PLANNING APPLICATION NUMBER:P14/1831

Type of approval sought	Full Planning Permission
Ward	Netherton Woodside and St Andrews
Applicant	Mr D. Vaughan
Location:	60, HILL STREET, NETHERTON, DUDLEY, DY2 0NX
Proposal	REMOVAL OF EXISTING FLUE AND INSTALLATION OF EXTRACTION FLUE FOR A PAINT SPRAY BOOTH (RESUBMISSION OF WITHDRAWN APPLICATION P14/1421)
Recommendation Summary:	APPROVE SUBJECT TO CONDITIONS

SMV Accident Repair Specialists
PROPOSED ALTERATIONS
60-61 HILL STREET
NETHERTON
REVISED PROPOSALS
14:88:01A

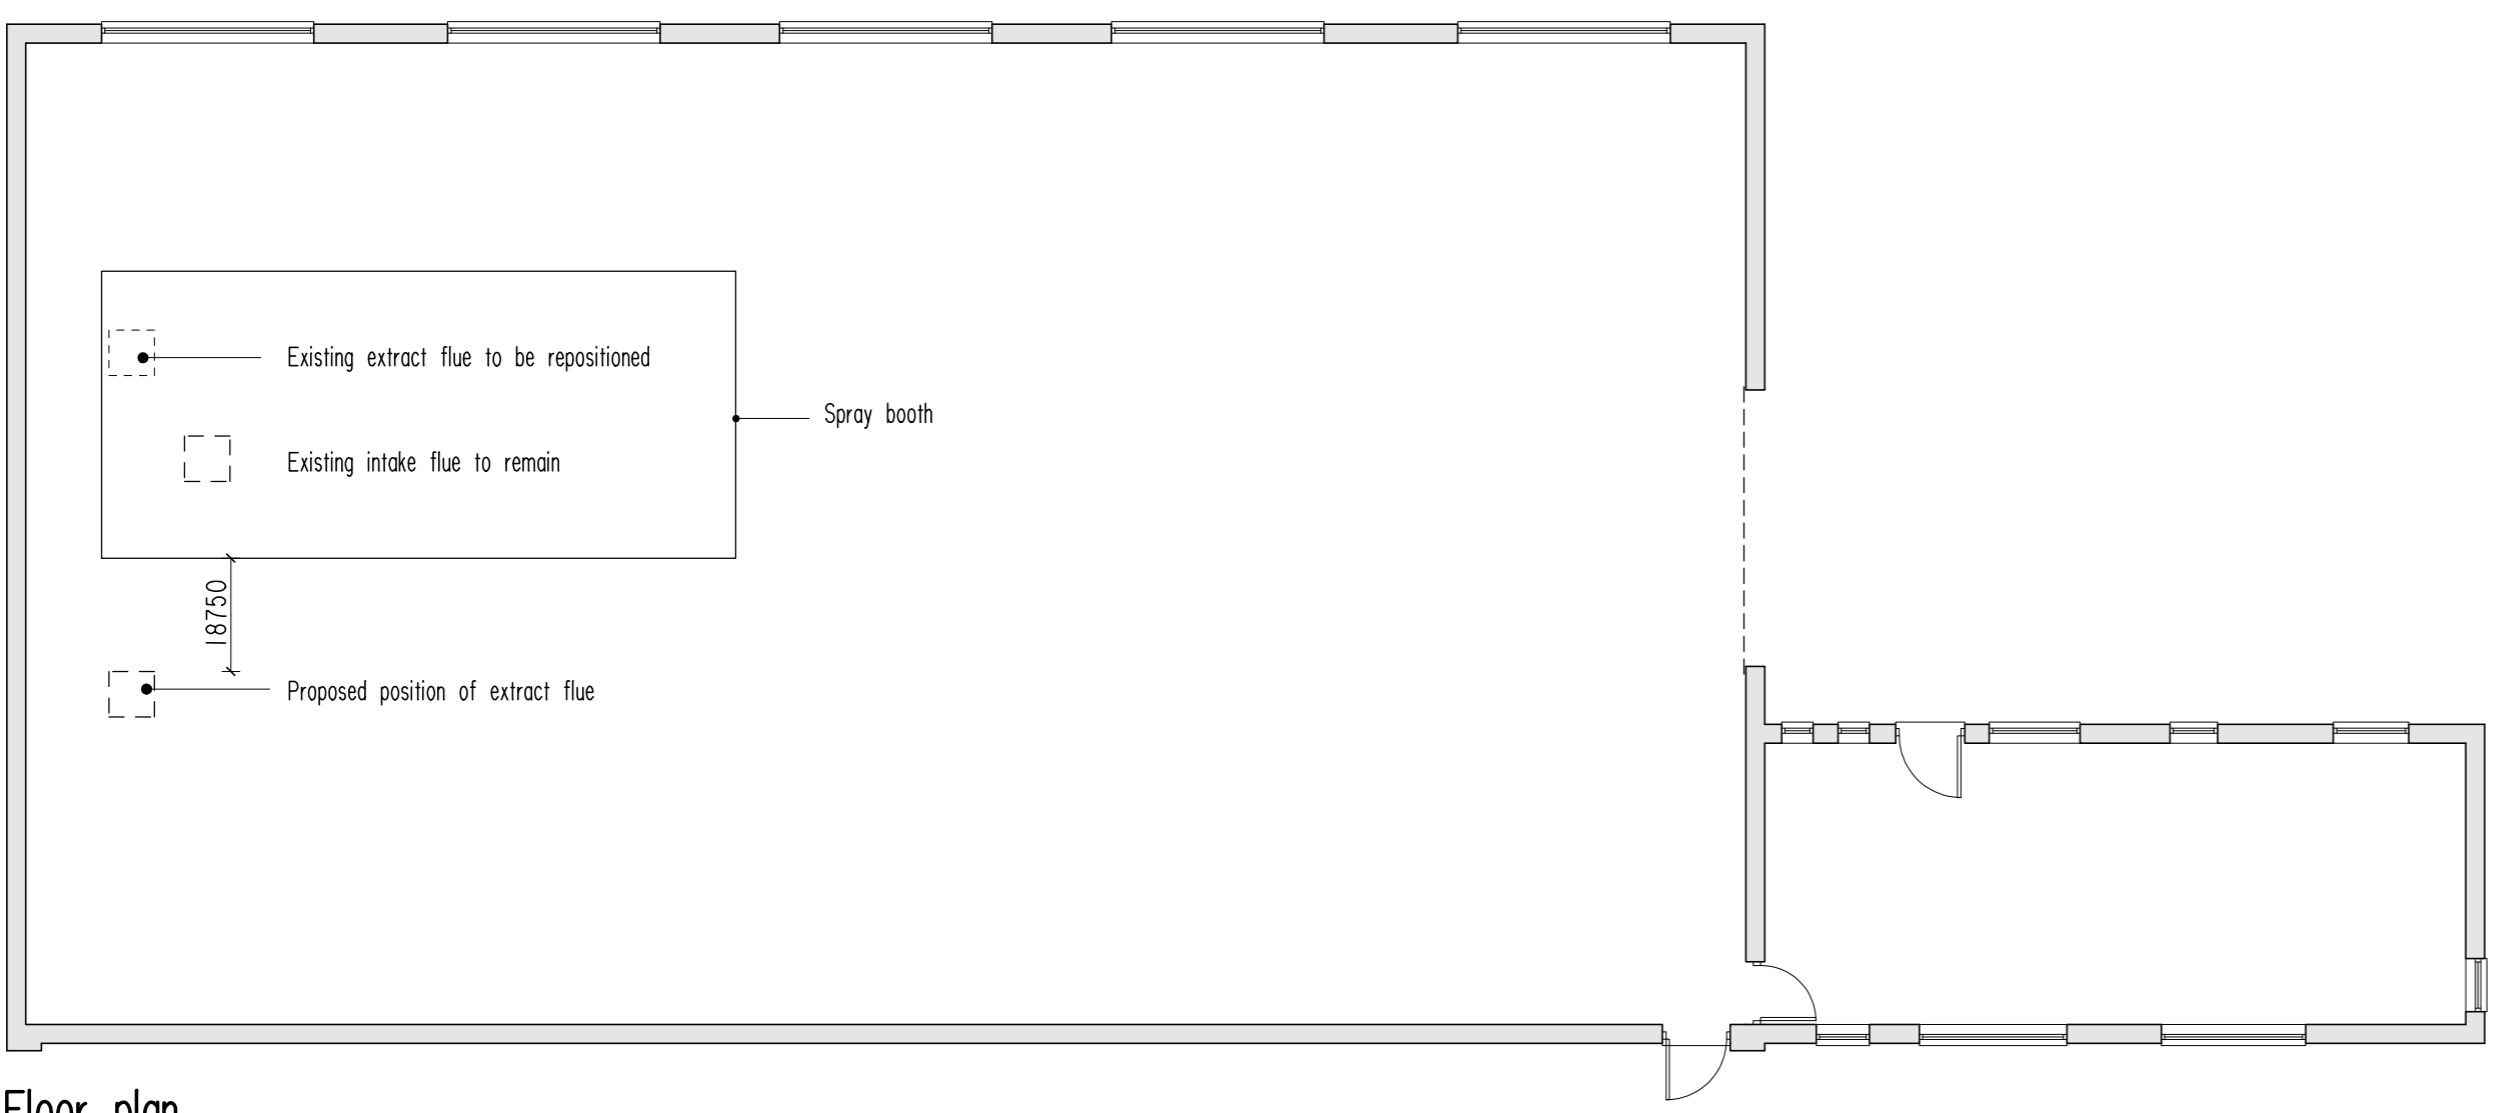
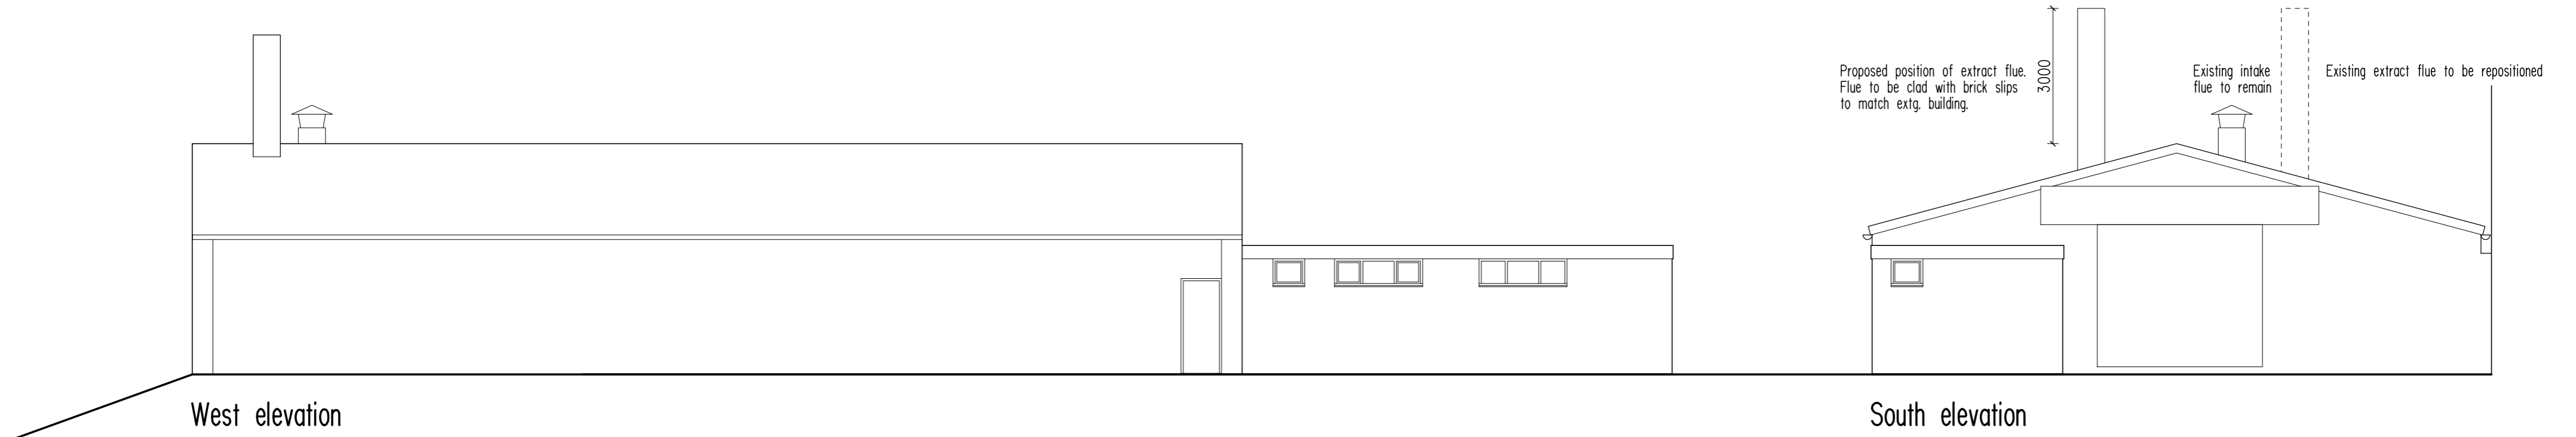
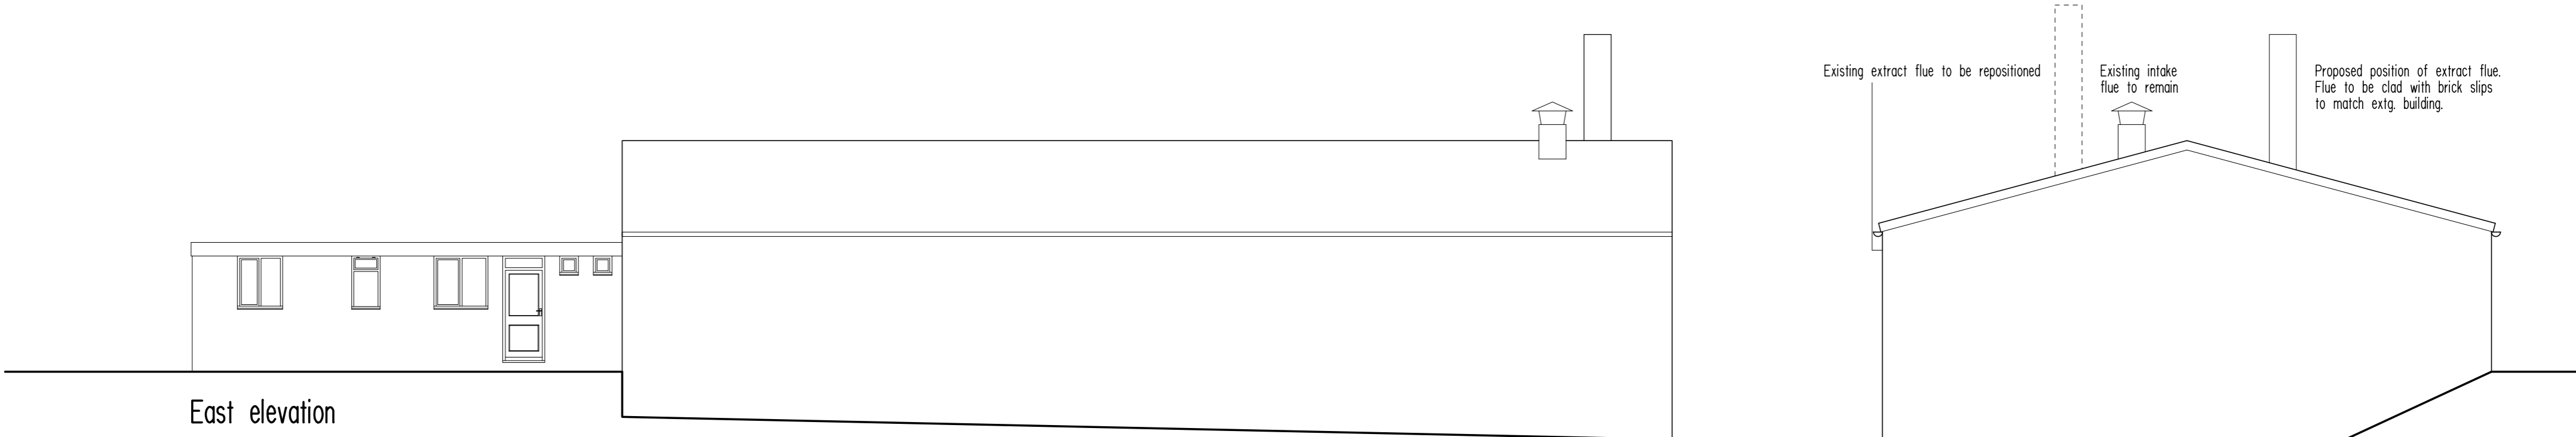
3. The unauthorised flue without the benefit of planning permission, as shown on Drawing no. 14:88:01 A shall be removed by the 31st March 2015.
4. The rating level of sound emitted from the extraction system as shown on Drawing no. 14:88:01 A shall not exceed the background sound level between the hours of 0700-2300 (taken as a 15 minute LA90 at the nearest sound sensitive premises). All measurements shall be made in accordance with the methodology of BS4142 (2014) (Methods for rating and assessing industrial and commercial sound) and/or its subsequent amendments. Where access to the nearest sound sensitive property is not possible, measurements shall be undertaken at an appropriate location and corrected to establish the sound levels at the nearest sound sensitive property. Any deviations from the LA90 time interval stipulated above shall be agreed in writing with the local planning authority.

6. The flue as shown on approved Drawing no. 14:88:01 A shall be enclosed in a material to closely resemble the facing brick on the front elevation of the workshop. The brick skin shall remain in place for the lifetime of the development.

A : 03/02/15 : Flue height amended.
Revisions:
